Subject: Transmittal of Class 1 Permit Modification to Remove Structures from the Los Alamos National Laboratory (LANL) Hazardous Waste Facility Permit, EPA ID #NM0890010515

Class 1 Permit Modification for Removal of Structures from Technical Area 63

Removal of Structures from Technical Area 63

FIGURE G.27-1.

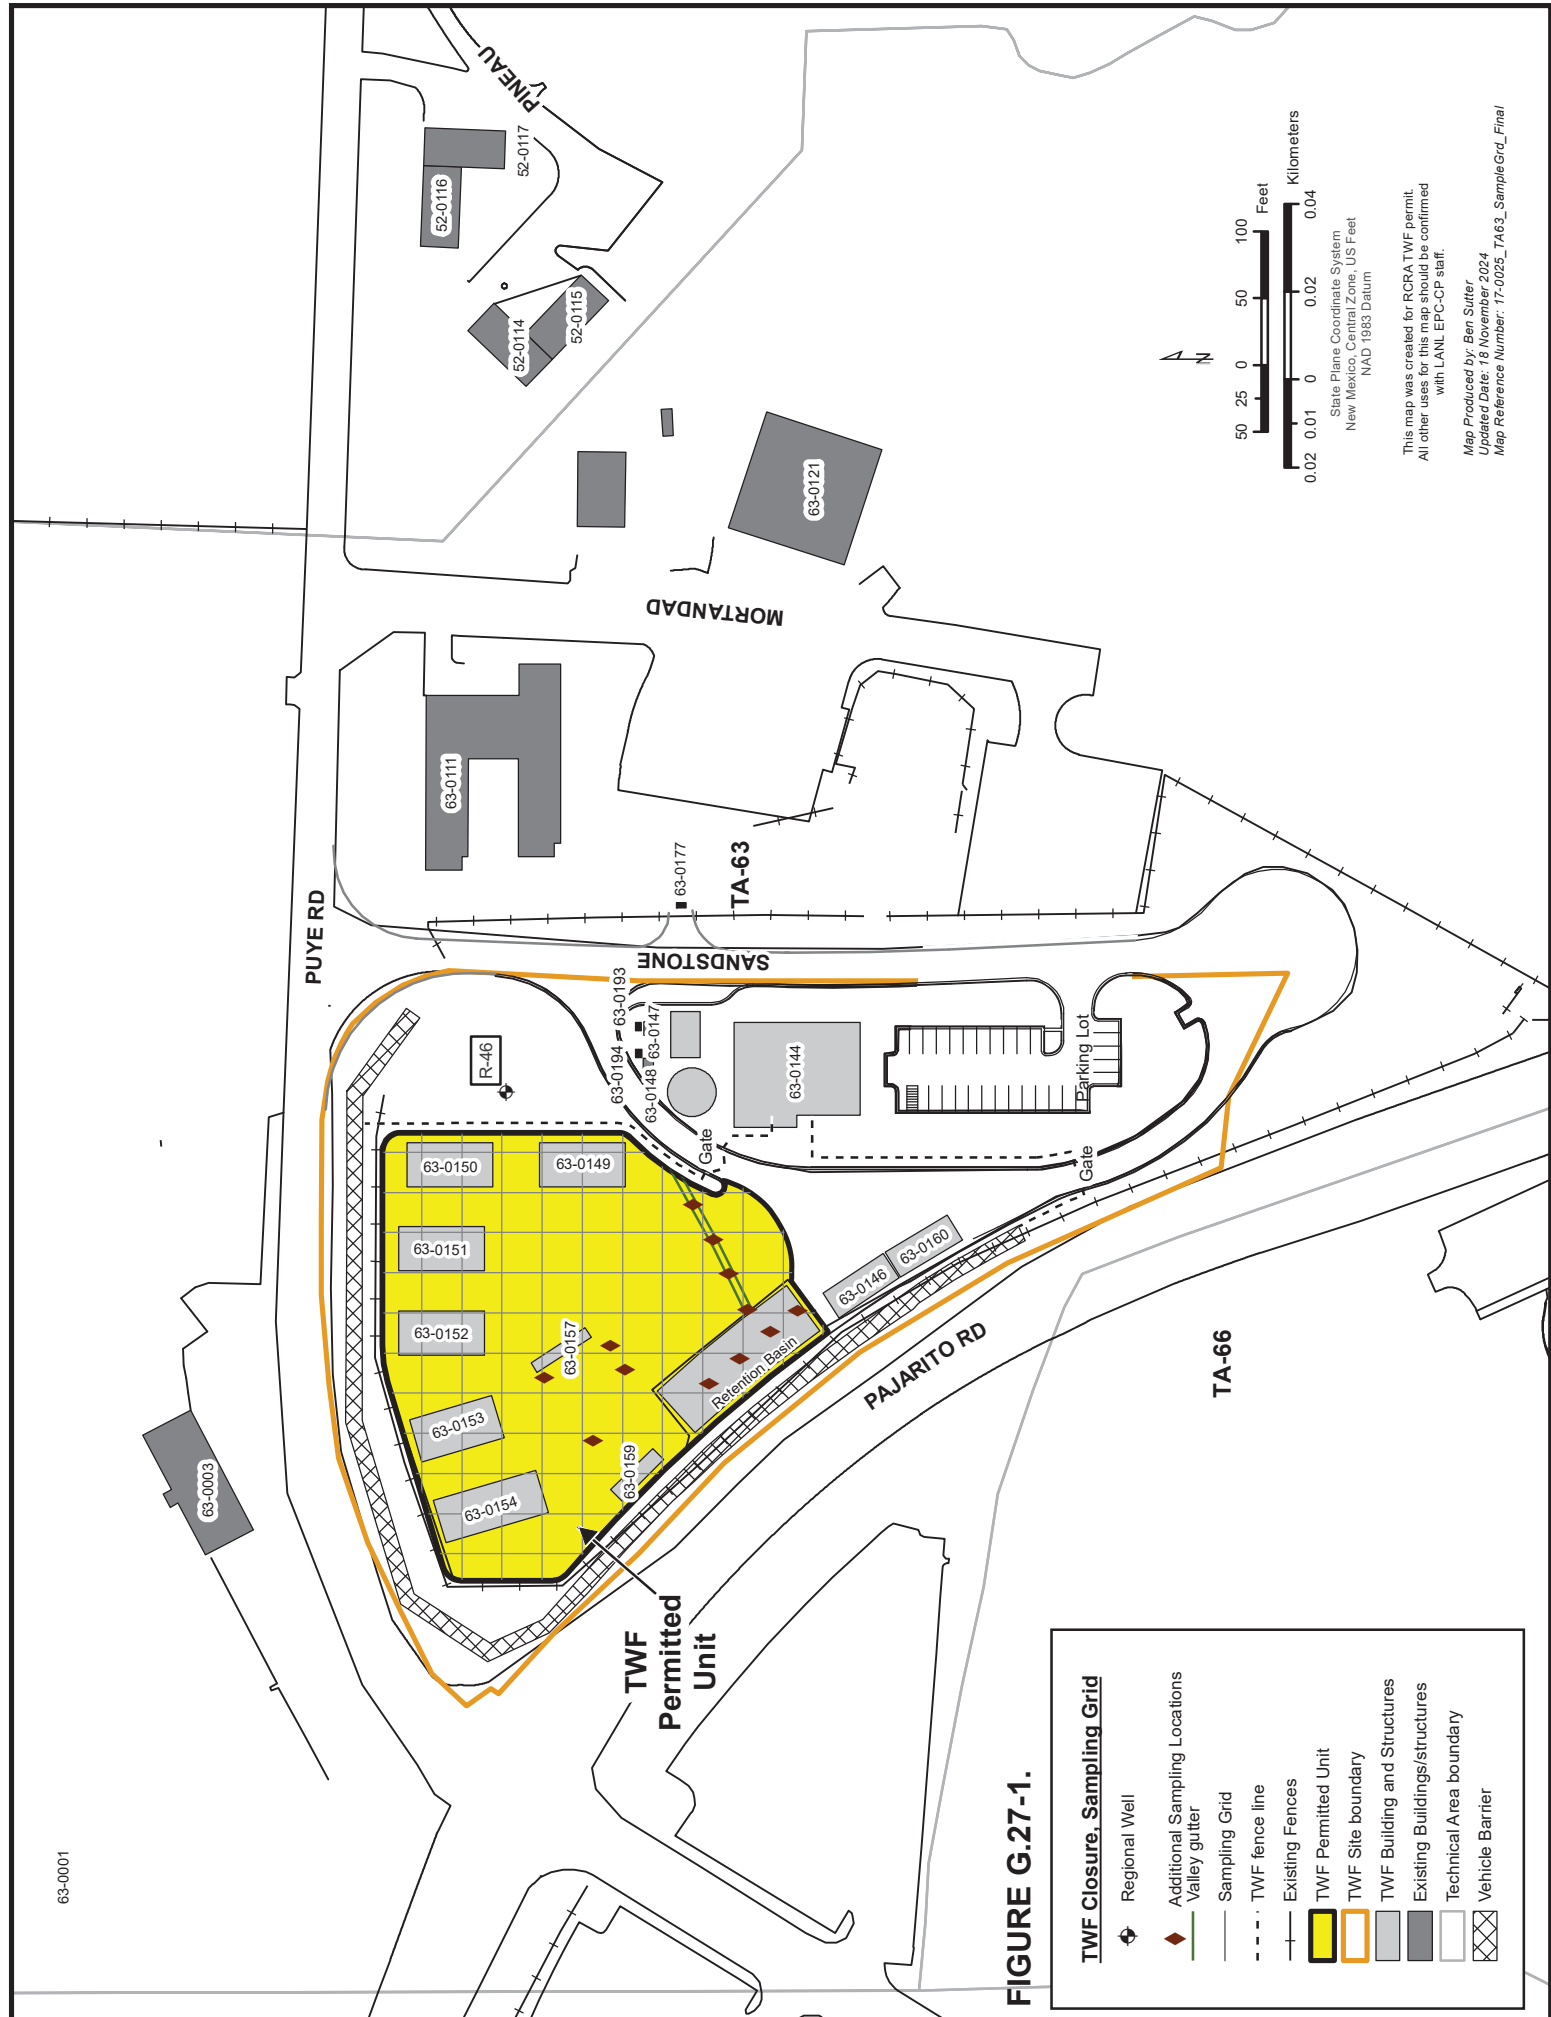
Attachment G.27, *Technical Area 63, Transuranic Waste Facility Closure Plan*, revision reflects the removal of structures TA-63-0155 and TA-63-0156 from the description of unit to be closed and an updated Figure G.27-1 is provided.

- Storage Buildings: 63-0149, 63-0150, 63-0151, 63-0152, and 63-0153
- Storage and Characterization Building: 63-0154
- Characterization Trailers: ~~63-0155, 63-0156, and 63-0157~~6
- Concrete Storage Pad

Figure 55

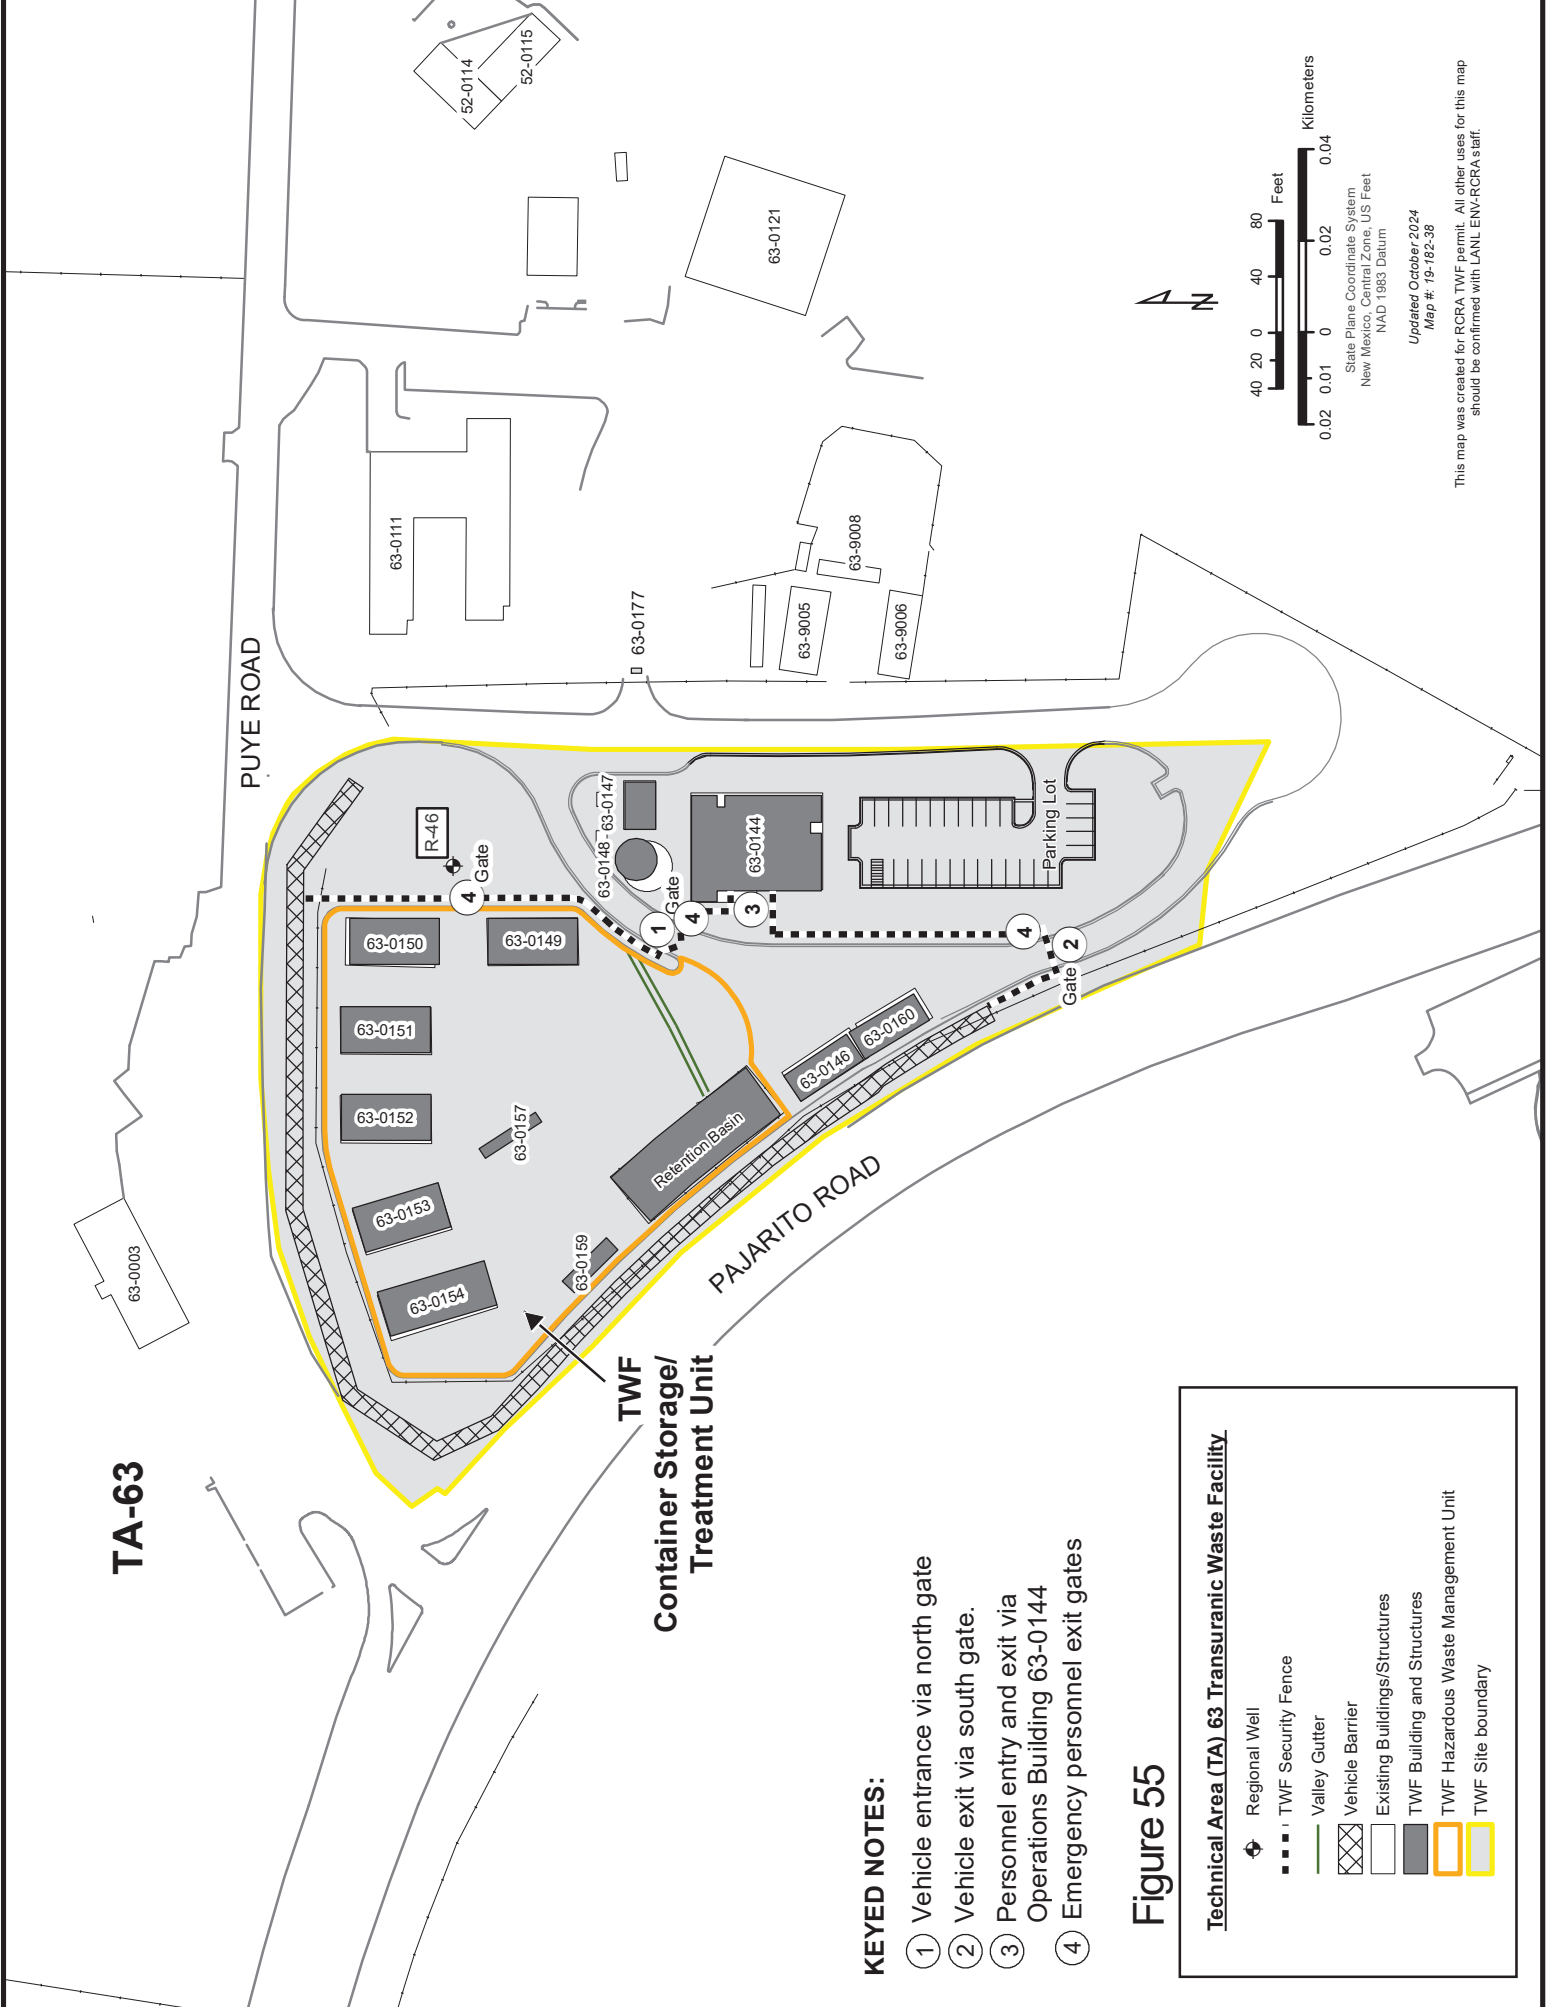
Attachment N, *Figures*, revision reflects the removal of structures TA-63-0155 and TA-63-0156 from Figure 55, *Technical Area (TA) 63 Transuranic Waste Facility*, and Figure 56, *Transuranic Waste Facility Subsurface Vapor Monitoring Network*.
